**CONSOLIDATED EDISON COMPANY OF NEW YORK, INC.
INDIAN POINT NUCLEAR GENERATING UNIT NO. 2**

**THIRD SUPPLEMENT TO:
PRELIMINARY SAFETY ANALYSIS REPORT**

ADDITIONAL INFORMATION REQUIRED

REINFORCEMENT DETAIL AT EQUIPMENT HATCH
PRELIMINARY 6.15.66

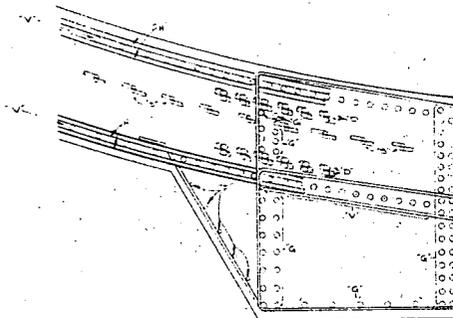
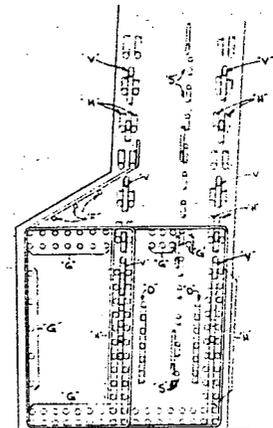
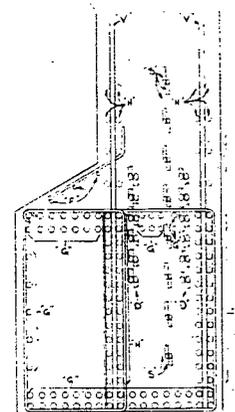
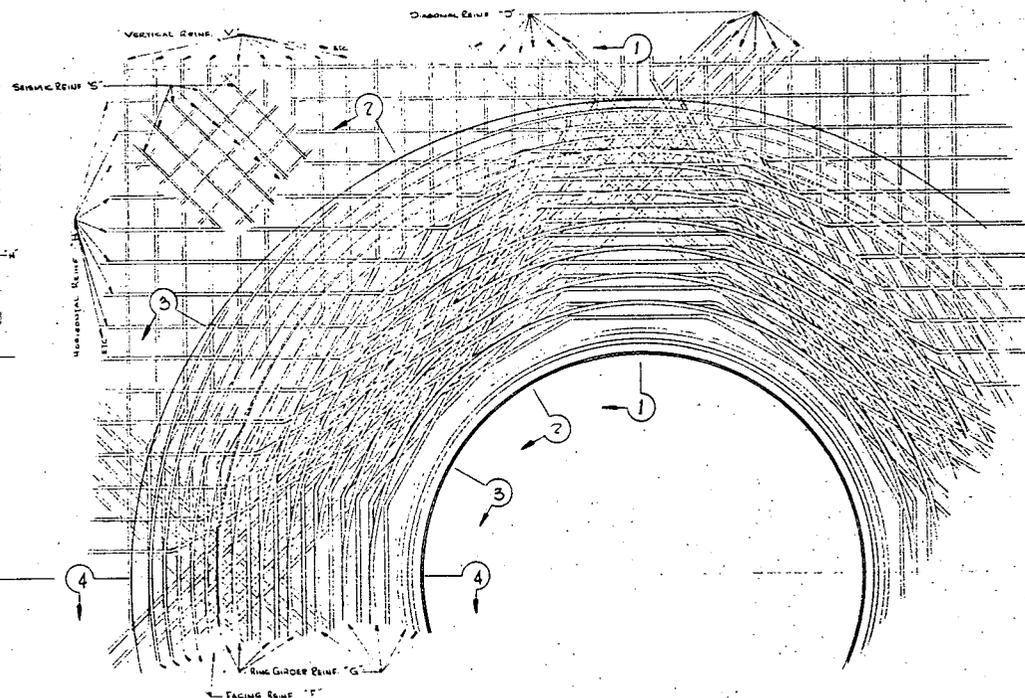
3. Placement of rebars and general design drawings should be provided for the large openings.

The attached sketch details the placement of reinforcing around the equipment access opening.
